**Re: Comments to Energy Star for Windows, Doors, and Skylights  
Version 6.0 Draft 1 Criteria and Analysis Report**

## **AGC Public Comments**

### **Energy Star for Windows, Doors and Skylights Version 6.0 Draft 1 Criteria and Analysis Report**

**Comments of AGC Glass Company North America to  
Energy Star for Windows, Doors, and Skylights  
Version 6.0 Draft 1 Criteria and Analysis Report**

**Figure 3**

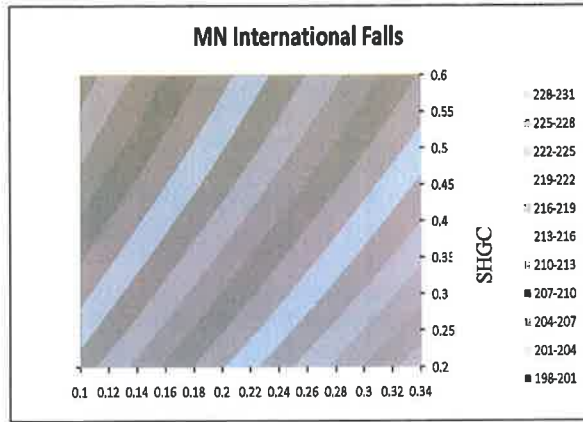
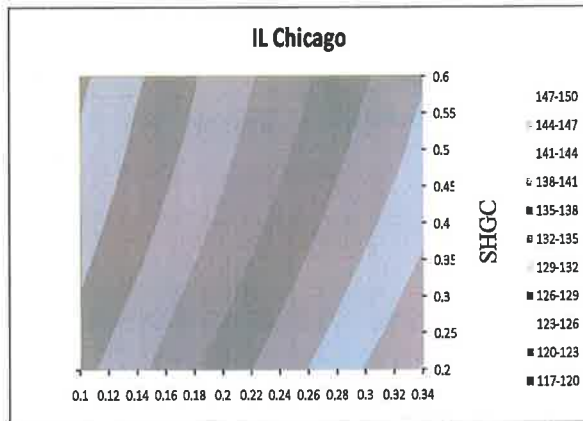
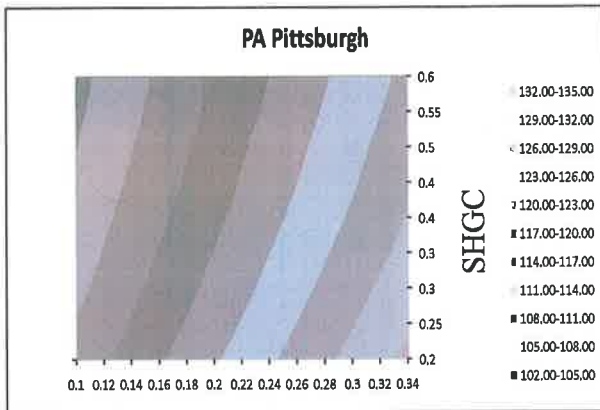
Figure 3 displays whole house (heating and cooling) energy consumption in Mbtu for the same three Energy Star Northern zone cities identified in Figure 2. The data reported is site energy. Each city has been charted and graphed. In each graph, each color band represents 3Mbtu’s of energy consumption – or shows the U-Value / SHGC combinations of windows that would result in whole house equivalent energy consumption.

**Figure 4 – Whole House Energy Consumption – D&R Products Available for Sale**

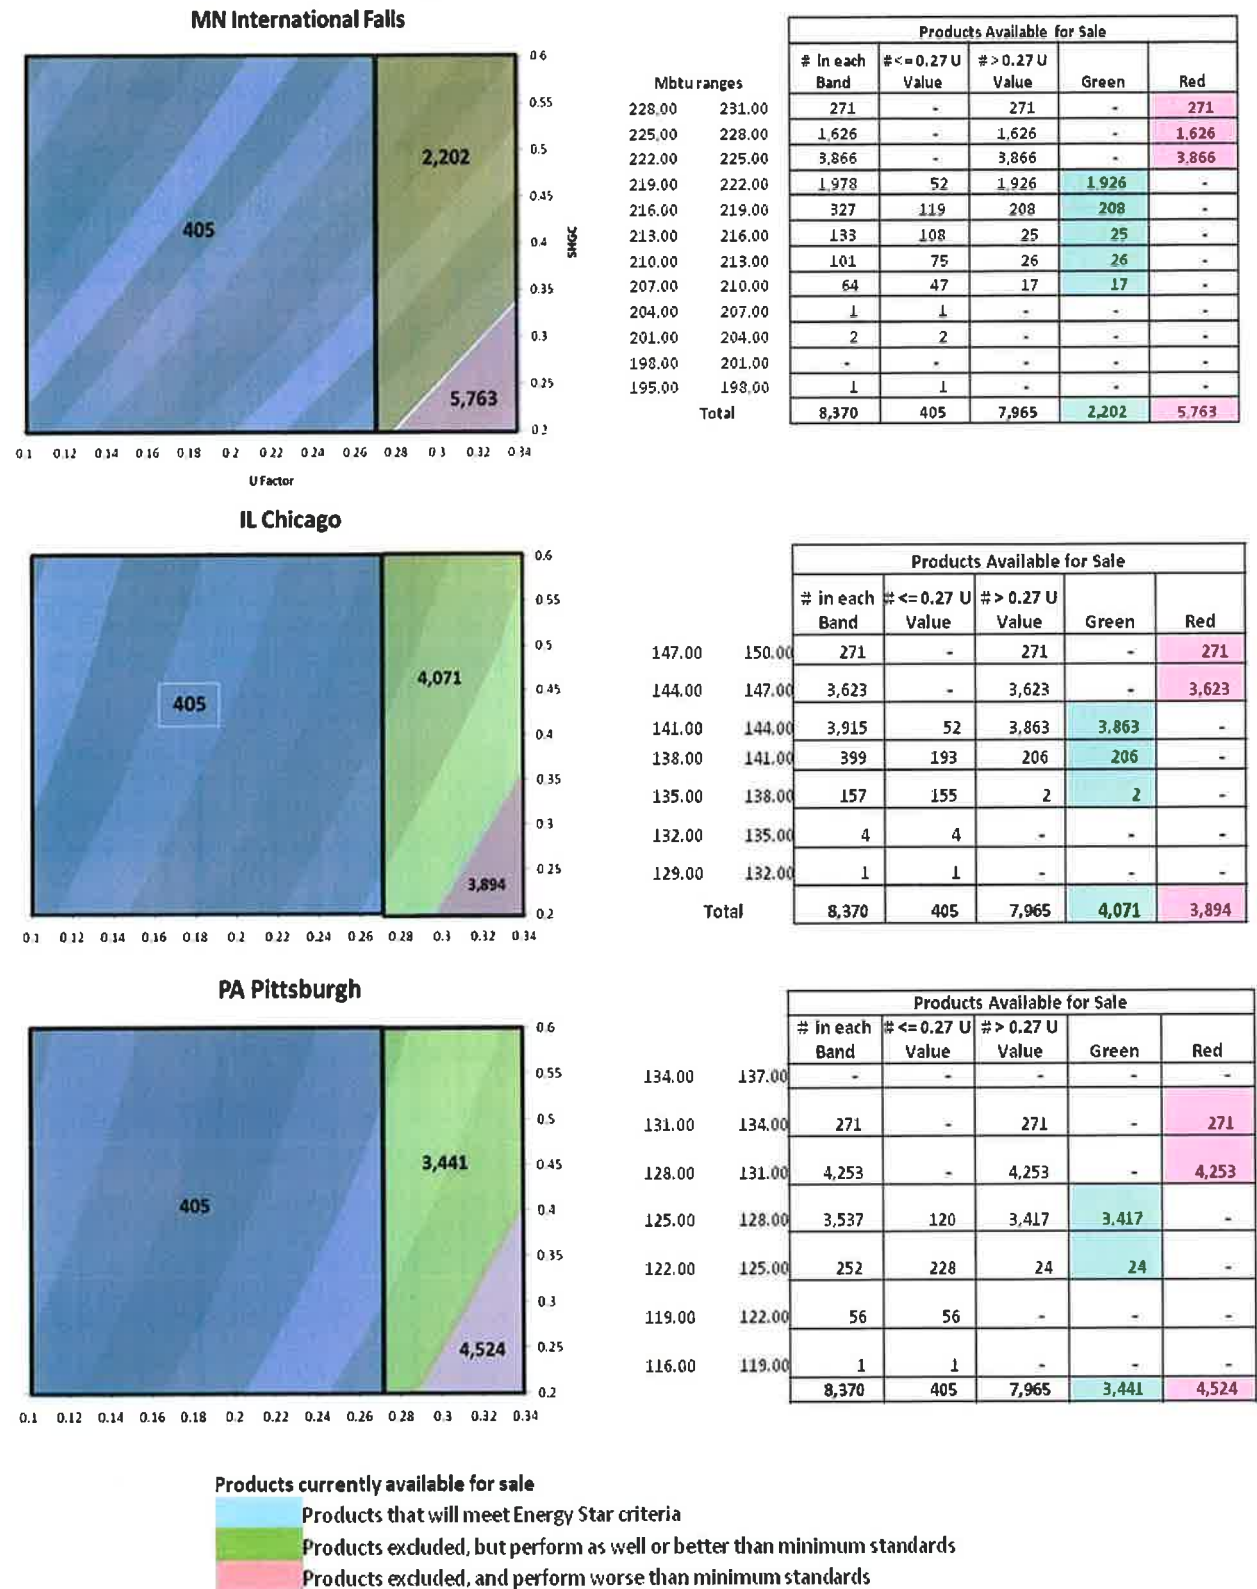
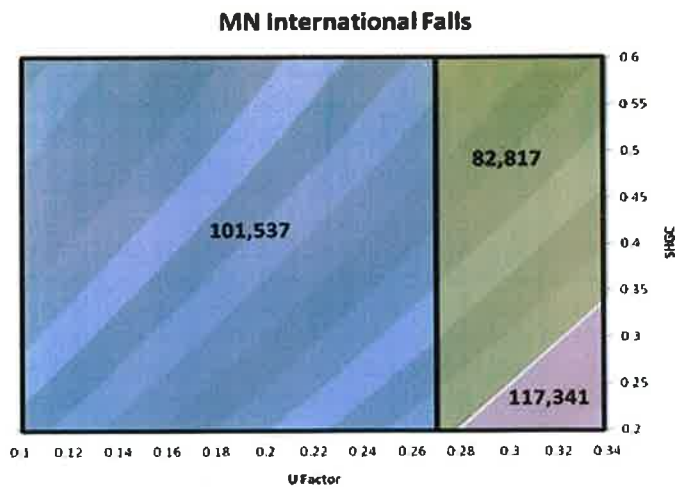
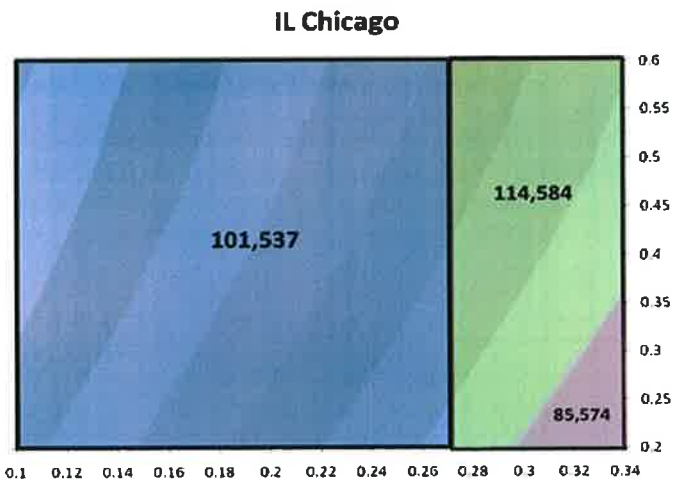
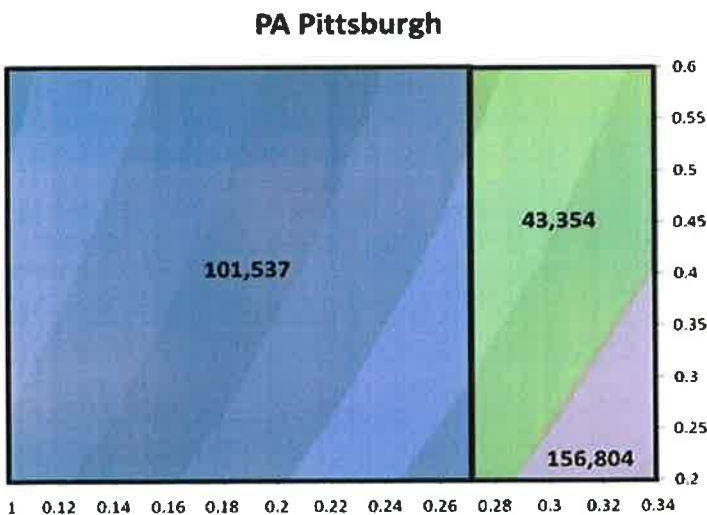
Figures 4 and 5 shows the results of our analysis. To determine products that meet the northern zone requirements, we looked at the whole house energy consumption for the window that consumed the most energy and still qualifies for the energy star criteria. Therefore, for each city the total Mbtu's for windows with 0.27 U-value and 0.20 SHGC were selected as the basis for comparison or "Benchmark". For each city modeled, there are three highlighted areas of interest (Blue, Green, Red). Energy performance and the number of available products that meet or exceed the benchmark are highlighted in blue. Energy performance and the number of products that are eliminated from the energy star program **but consume less energy than the benchmark** are highlighted in green. Energy performance and the number of products that are eliminated that consume more energy than the benchmark are highlighted in red.

Figure 4 - Available Products for Sale dataset, 4.8% of the products meet the Energy Star criteria. International Falls, Chicago and Pittsburg have 26.3%, 48.6% and 41.1% respectively of the Products Available for Sale that consume less than or equal to the energy of windows that meet the Energy Star criteria. 68.9%, 46.6% and 54.1% respectively consume more energy than the benchmark and are properly eliminated from the Energy Star Program.

Figure 5 - CPD Available Products for Sale dataset, 33.6% of the products meet the Energy Star criteria. International Falls, Chicago and Pittsburg have 27.4%, 38.0% and 14.4% respectively of the Products Available for Sale that consume less than or equal to the energy of windows that meet the Energy Star criteria. 39.0%, 28.3% and 52% respectively consume more energy than the benchmark and are properly eliminated from the Energy Star Program.

Based on this analysis, it is fair to conclude that Energy Star criteria for the Northern Energy Star zone will mislead consumers in selecting and evaluating window performance, as well promote window performance that will increase whole-house energy consumption and national energy consumption.
